Project: Kackman Creek Culvert Replacement Project Date: February 28, 2020

$Project \ Manager: \ \underline{ \ Carole \ Kirk, \ Stillaguamish \ Tribe \ of \ Indians } \qquad \qquad Bid \ Opening: \ \underline{ \ March \ 5, \ 2020 \ 2:00PM }$

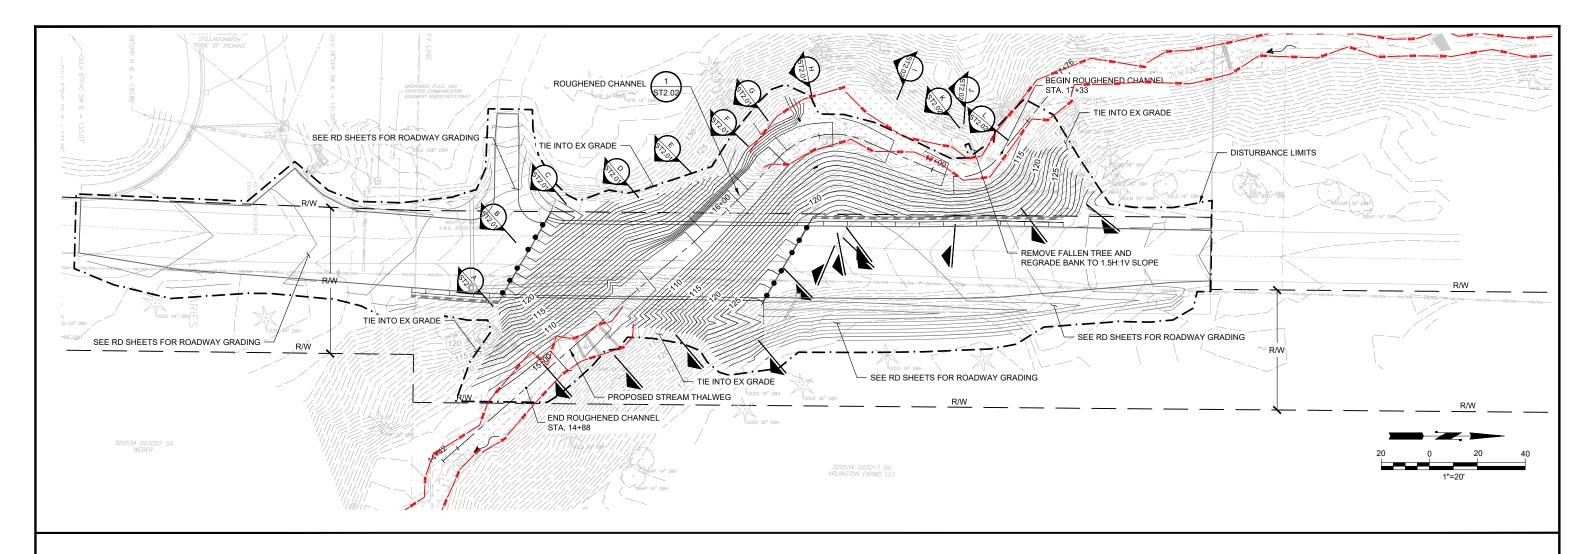
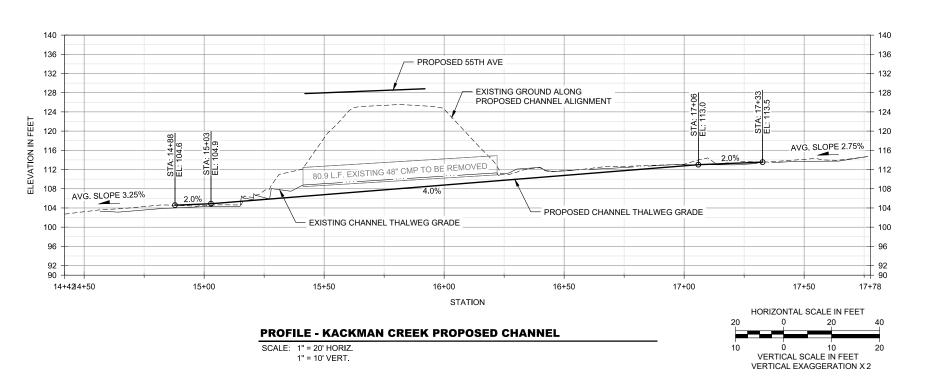
Questions and Answers List		
#	QUESTION	ANSWER
1	What is the Engineer's Estimate?	The Tribe does not share this information.
2	Can the Contract Plans more clearly designate the location of the OHW?	A Figure called "Addendum1-OWH Figures.pdf" based on Drawings ST1.01 and ST1.02 is attached which shows the OWH in red and updates the drawing order to bring the OHW line to the top for enhanced clarity.
3	Does the Project have specified number of working days or a timeline with an end date for substantial completion?	There is no specified limited number of working days but the project duration is provided in the Bid Documents under the Instructions to Bidders, Item 4 Completion Time. Please note the updated anticipated NTP start date of March 31,2020 and the updated OHW work window of July 16-September 15 in Addendum 1. The November 15, 2020 date of substantial completion remains unchanged. There is additional information provided under the Instructions to Bidders, Item 3 Work Hours and Special Time Limitations. Also, see Section 1-08.9 Liquidated Damages, of the Contract Specifications, for the Liquidated Damages Formula for Work to be completed below OHW.
